Subject: INLET AND OUTLET SUIT VENT AIR TEMPERATURE MEASUREMENTS

FLIGHT TEST SAM

TITLE: *INSTRUMENTATION - PRE-
SUIT VENT AIR TEST*

PURPOSE: *TO ACQUIRE TEMPERATURE
DATA ON SUIT VENT AIR.*

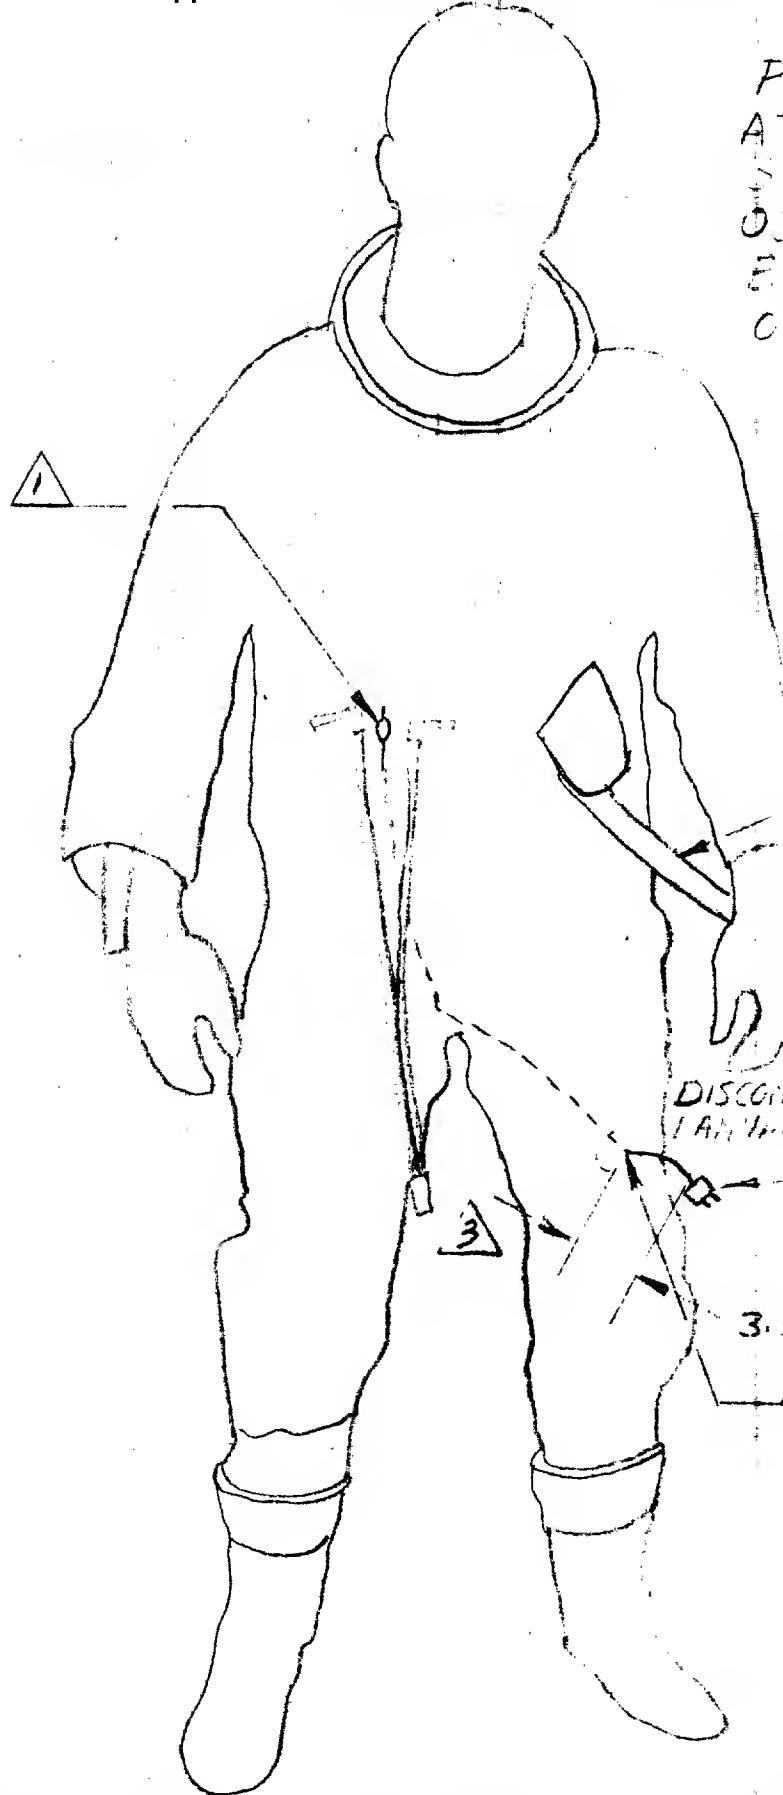
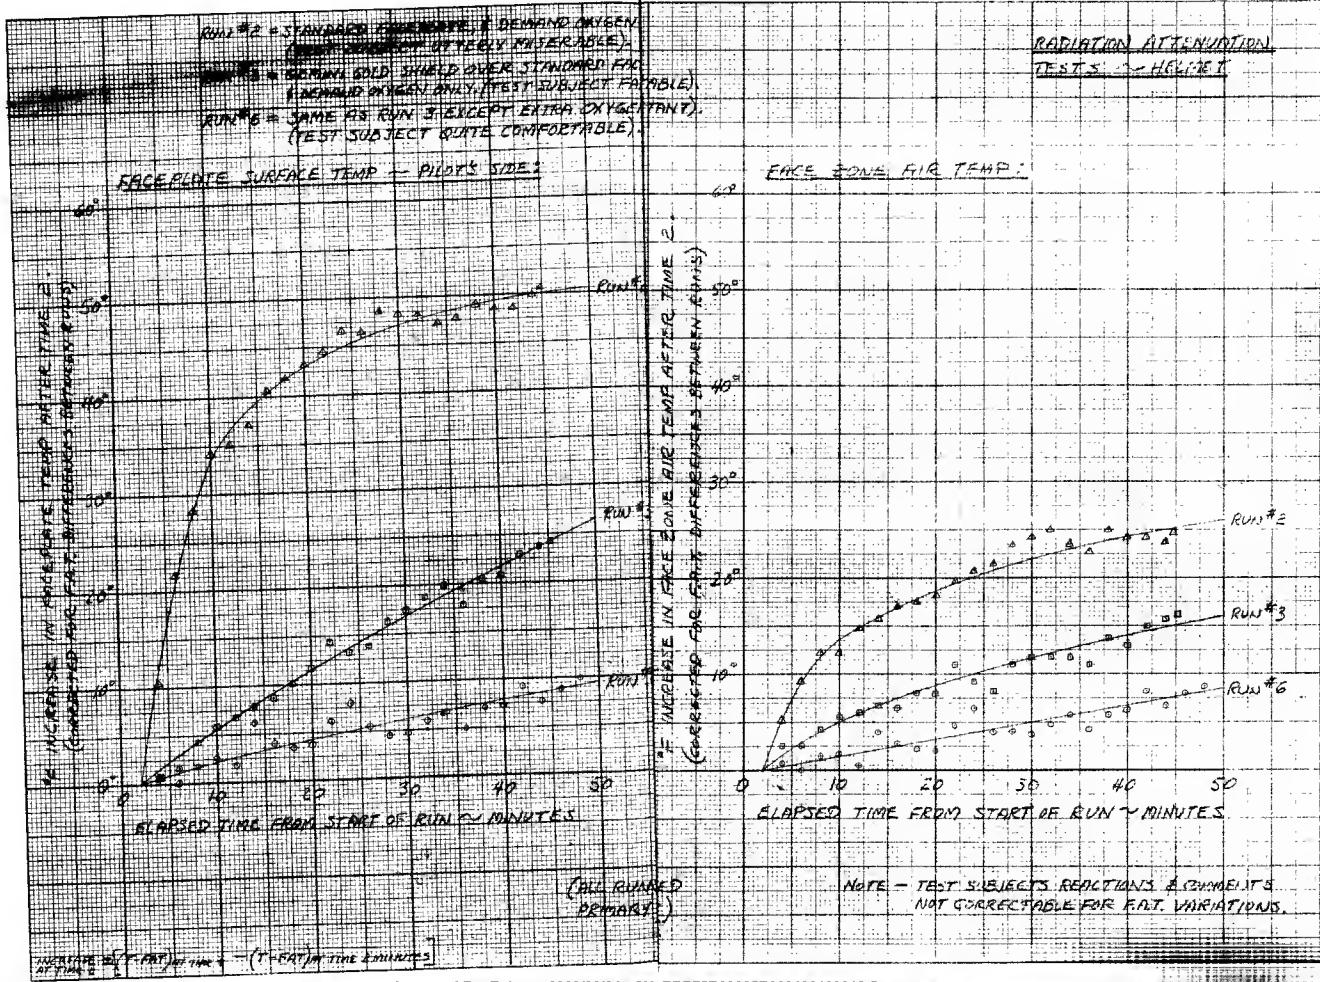
DESCRIPTION OF CHANGE:

1 ADD THERMOCOUPLE

PER E. KORBIN & GATINEAU
AT BN-3. LOCATE INSIDE
SUIT AT SUIT CONTROLLER
OUTFLOW VALVE PER P.
EXPOSE AT BN-3 FOR
OPERATION

2 EXIT AT ALTIMETER
FITTING. EPOXY
AROUND HOLE TO
SEAL AGAINST AIR
LEAKAGE. DRILL MIN.
HOLE SIZE

AMO
LINES = 1/4" I.D.
ELBOW - 1" REG.
DRILL 1/4" DIA.
HOLE MISER 1
THERMOCOUPLE
EPOXY TO 1/4" DIA.
LOCATE OUTBOARD
DISCONNECT
JACKETED
TYPE 1400 PLUG, 1/4" DIA.
THERMOCOUPLE 1/4" DIA.
ADJUST PLUG & PATCH
3.00 JACK TO MAX. RELEASE
FORCE OF 10 LBS.
ROUND EXPOSED
CORNER SEE FTAG Q.7
SHEATH NEED TO
PREVENT DAMAGE
WHICH AND INSIDE 1011
DURACO PILOT'S LFG
MATERIAL. AVAILABLE
AT BN-3

3 NOTE: MOCKUP AND CHECK LENGTH
WITH PILOTS BEFORE
MAKING
